1. Sumner Food Bank Design Review - 15703 & 15625 Main Street
2. Sumner Food Bank Cross Access Review - 15703 & 15625 Main Street

DIRECTOR’S DECISION – DESIGN REVIEW
DEVELOPMENT SERVICES DEPARTMENT

Proposal Description: Construct a new community food bank, along with an associated warehouse and office space. The existing food bank building will be demolished, and new parking, circulation, and utilities will be constructed to serve the new structure.

Permit Number: DR-2025-0004

PROJECT: SUMNER COMMUNITY FOOD BANK SITE AND BUILDING IMPROVEMENTS
SHEET TITLE: CITY OF SUMNER DESIGN REVIEW SITE PLAN
SHEET NO: EX-001

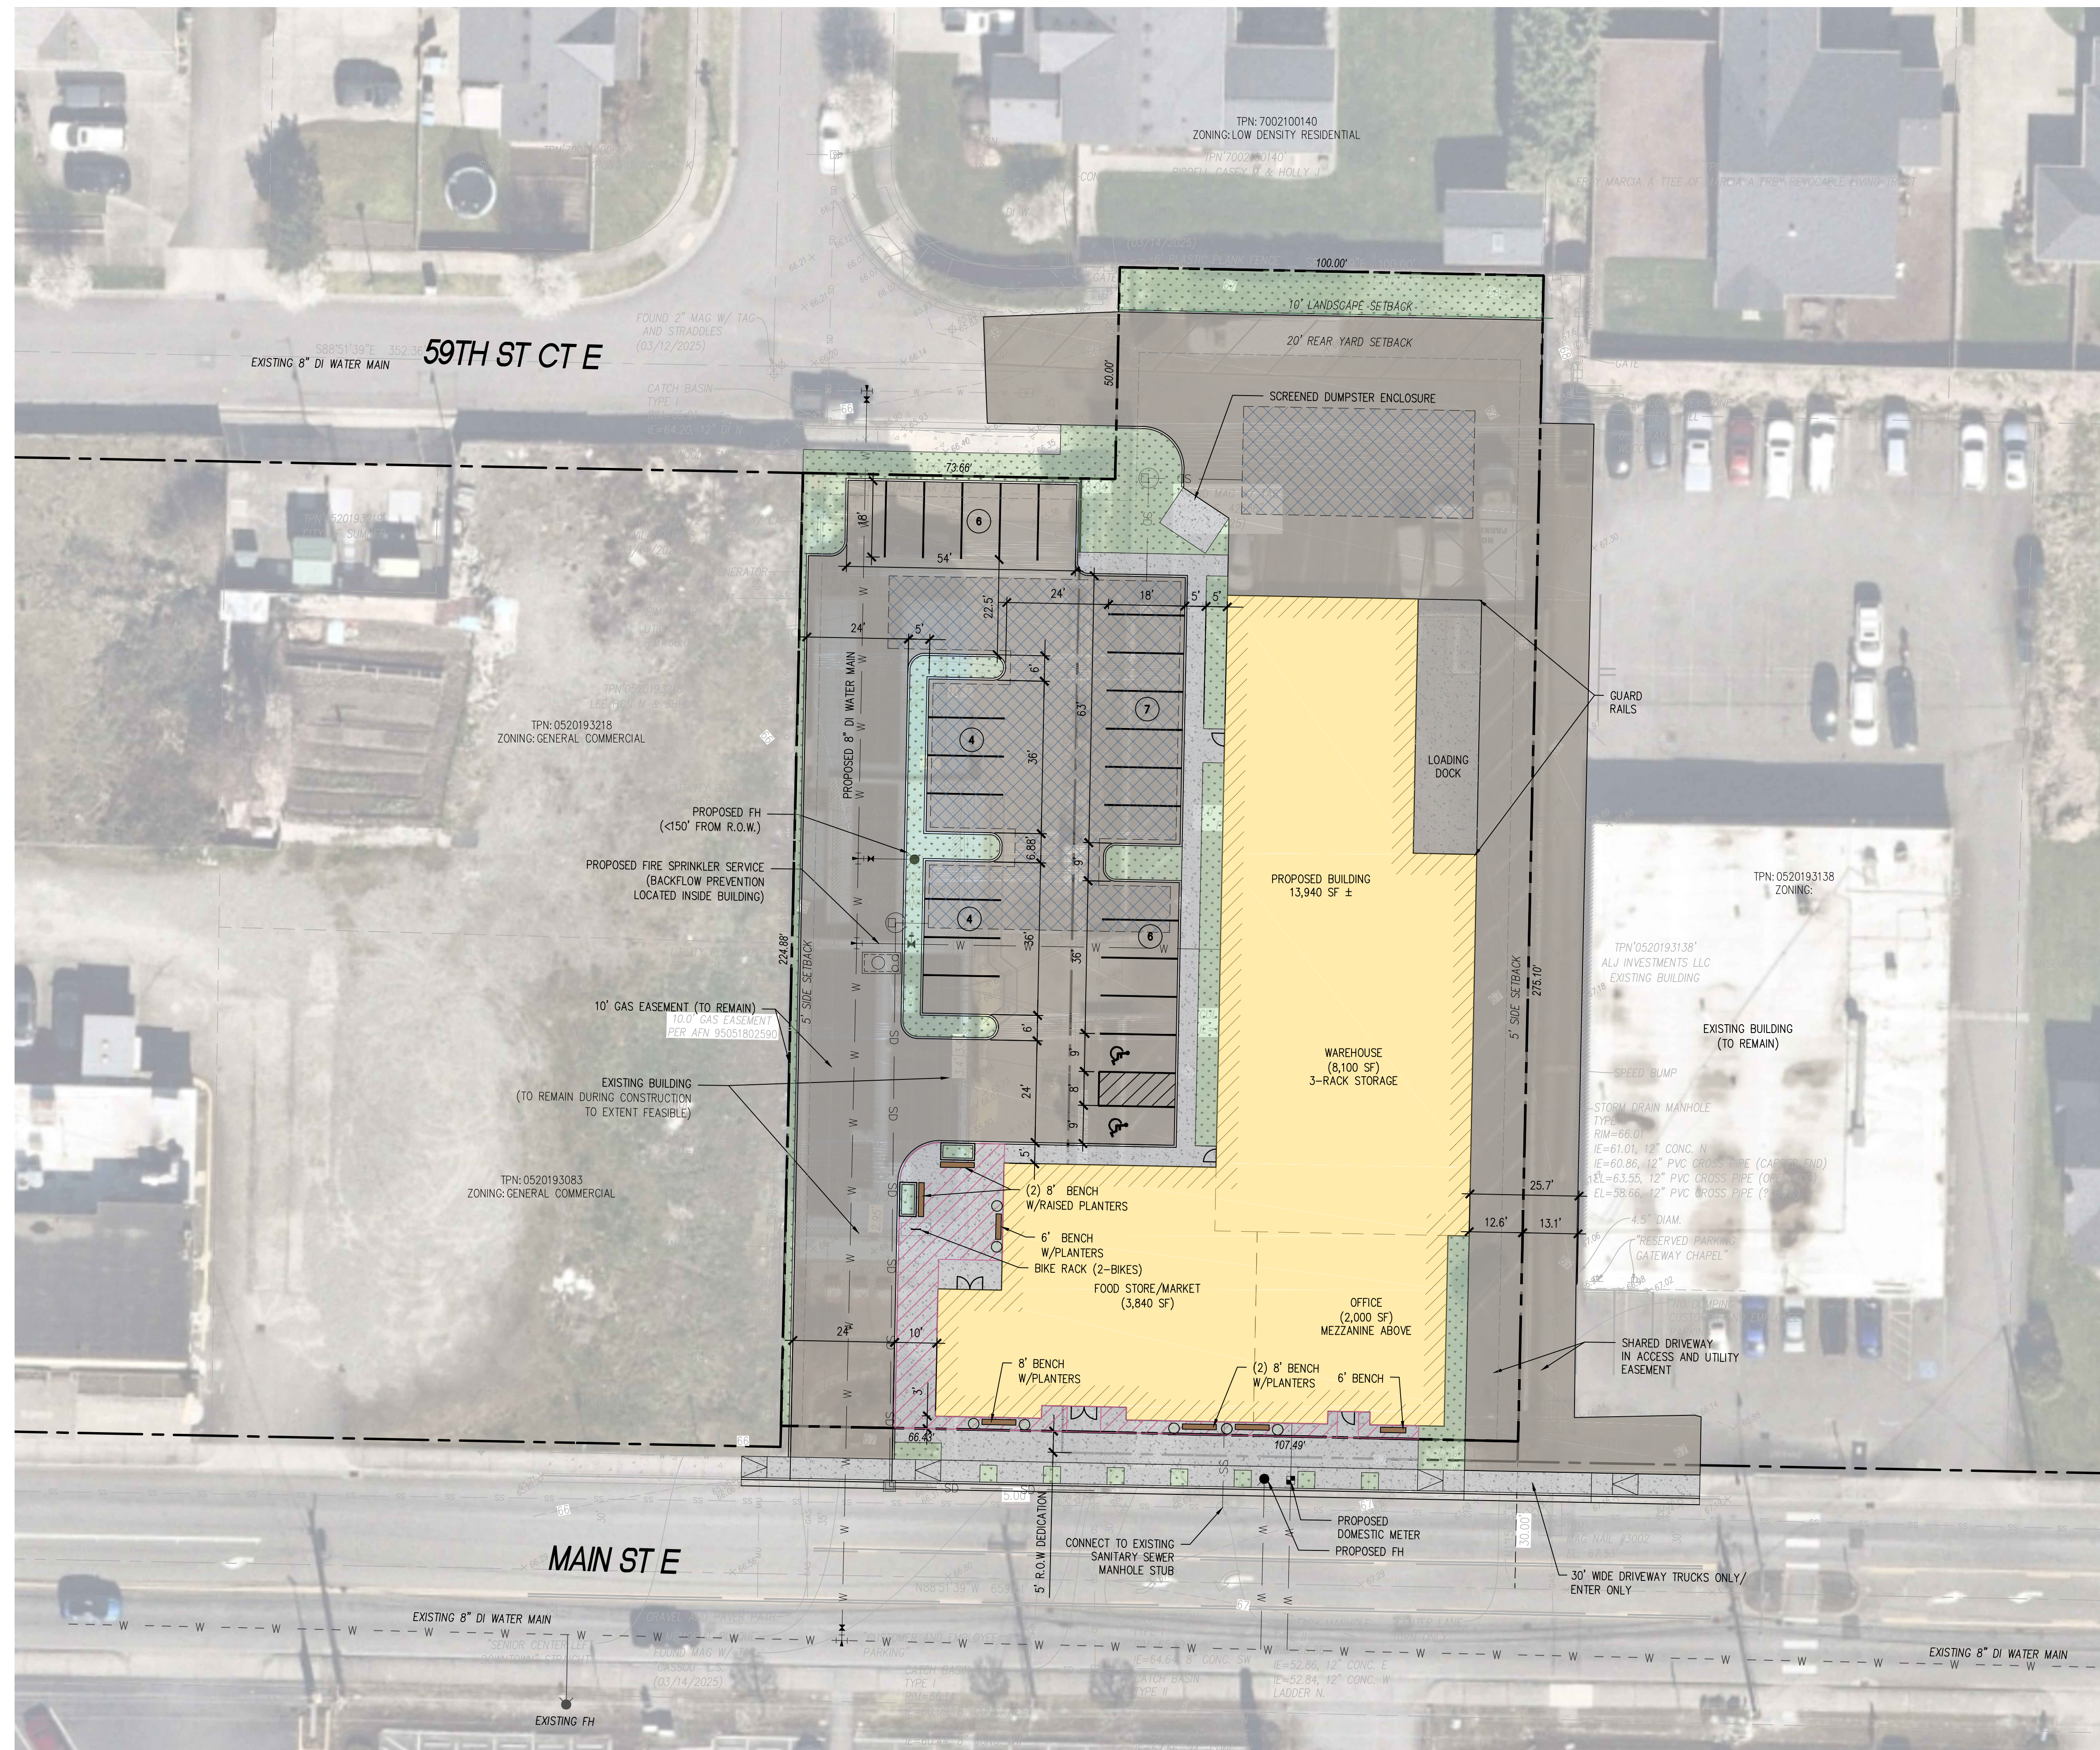
Compliant; the proposal involves two access points, and it should be noted that the eastern access is part of a required cross access corridor to encourage vehicular movement off Main Street. The western driveway access proposed will only serve as the customer parking lot, but upon development of the parcel to the west it will become a shared access way in conjunction with the new development. To accomplish this, the applicant is seeking a modification as allowed in SMC 18.43.140 and has submitted responses to the criteria to grant this modification. While driveways along East Main Street are discouraged, there is an approval mechanism for them. This is addressed as conditioned.

Compliant; the development provides access by creating a required cross-access corridor requirement to East Main Street, removing one of three access points to the site, and providing a shared access point to connect with future development to the west.

Compliant; 1,022 square feet of pedestrian-oriented space is required, and 1,260 square feet of pedestrian-oriented space is proposed. All requirements are met within this guideline, including pedestrian furniture provided at the front, acknowledgment of the lighting of 2-foot candle average, and seasonal planters.

Compliant; the site provides Type A Landscaping buffering residential homes, and Type C Landscaping otherwise, with the western side buffer providing no landscaping for future shared access development on the neighboring parcel.

B. The proposed modification to the East Main Street driveway standard as depicted under DR-2025-0004 is APPROVED per SMC 18.43.140 and subject to the following CONDITIONS:

1. A memorialization of the future cross access corridor and shared driveway with the western and eastern adjacent properties and public access to be constructed and dedicated per SMC 18.43.

2. Stamped and stained concrete will be used in the driveway approach connecting to the sidewalk to clearly identify access as approved by the City Engineer.

3. Signage relating to access and parking shall be installed prior to development and building approvals.

4. Truck access delivery shall be designed not to interfere with cross access corridor/East Main Street traffic.

5. Applicants should consider ways to delineate between truck bay access and public cross access. Options can involve curbing, signage, striping or other means.

A EXTERIOR ELEVATION - EAST
SCALE: 1/8" = 1'-0"

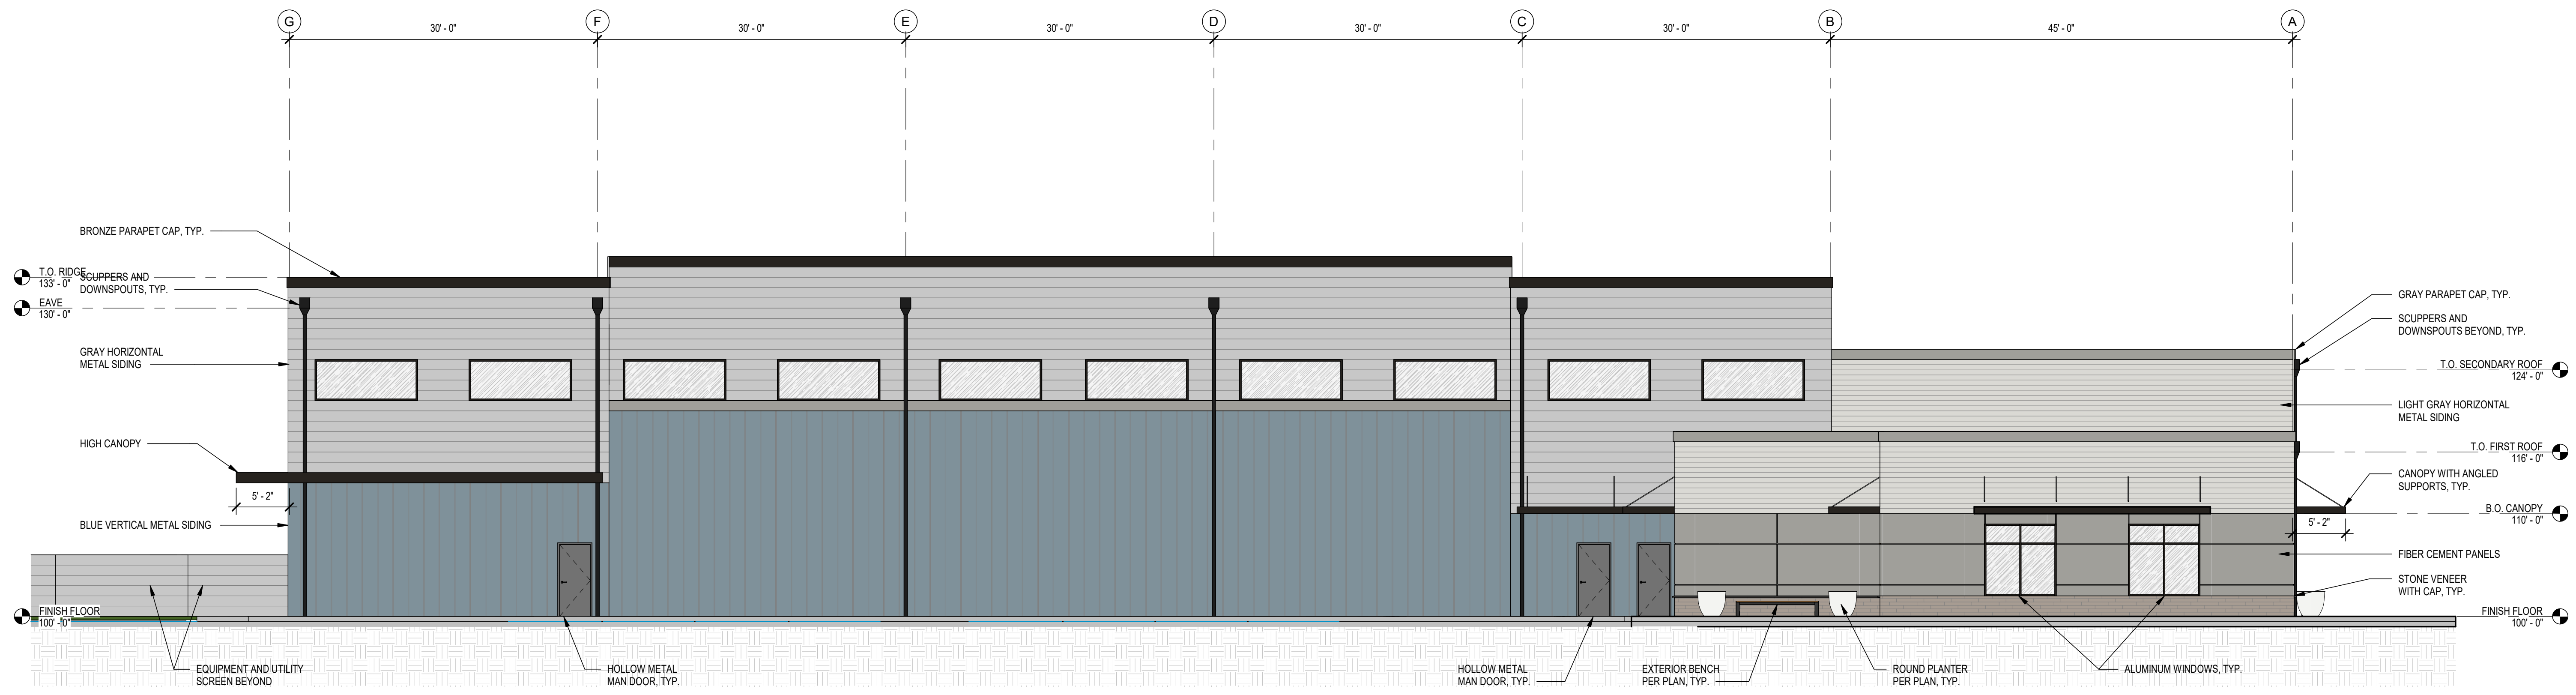
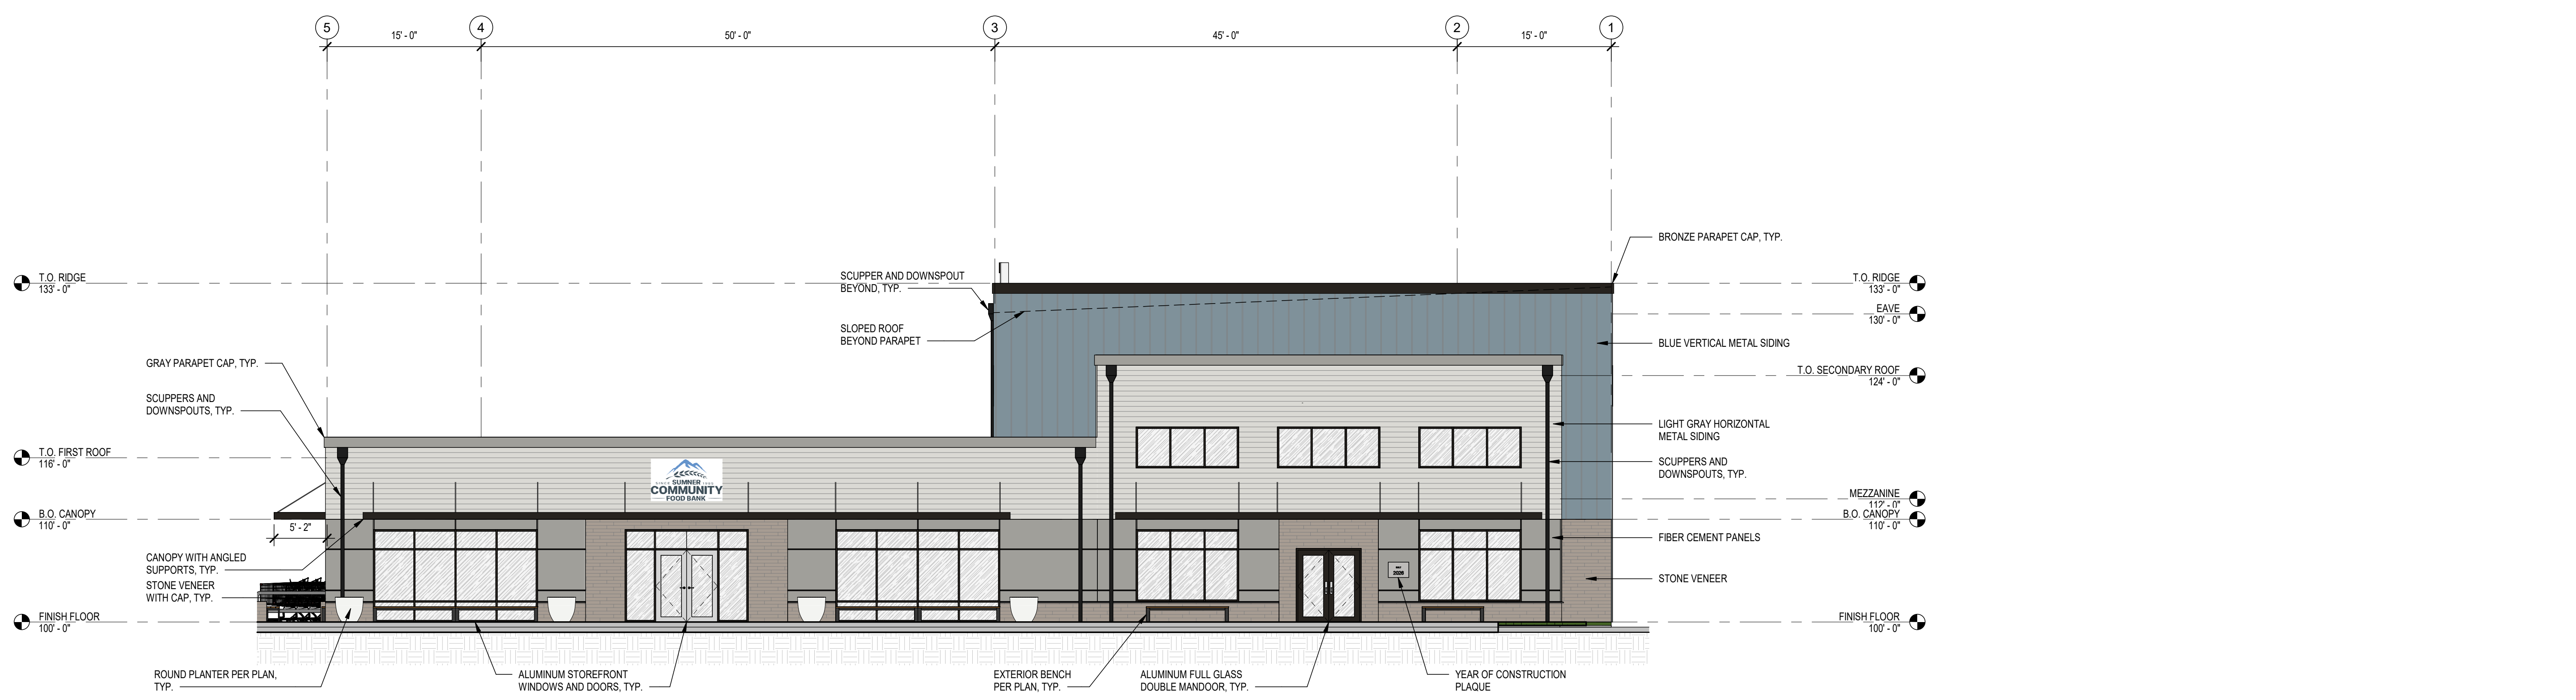
Compliant; all sides have been given equal consideration and meet required standards. The eastern elevation is addressed within Condition 4 and 5 under different standards. Each side has consistent design elements such as fiber cement paneling, weather protection, windows, landscaping, and stone veneer.

Compliant; metal siding is used throughout and among the most visible façades they use masonry, however, on the east and west side there staff feels it is visible but we would like design commissions take on possible CMU. Condition/recommendation

1. DG 2.5.4 Prior to building permit issuance, any new lighting shall be included and described, lighting shall either be down shielded or low to the ground.
2. Any future above ground utilities or mechanical equipment needs to be screened from the view of neighboring properties and the ROW.
3. DG 2.2.1 Applicant should develop a pedestrian pathway creating a stub-out connecting the pedestrian-oriented plaza space to the undeveloped parcel for future development pedestrian circulation access.
4. DG 2.3.10 Applicant should determine means of addressing the blankness of the eastern metal siding

and avenues of creating visual interest. This could involve material, color changes, murals, artwork, etc.

5. DG 2.4.5 Applicant should consider means to protect the metal siding on the eastern portion of the building within the street access with either masonry as required in 2.4.5, recommendation by Commission, or other determined means.
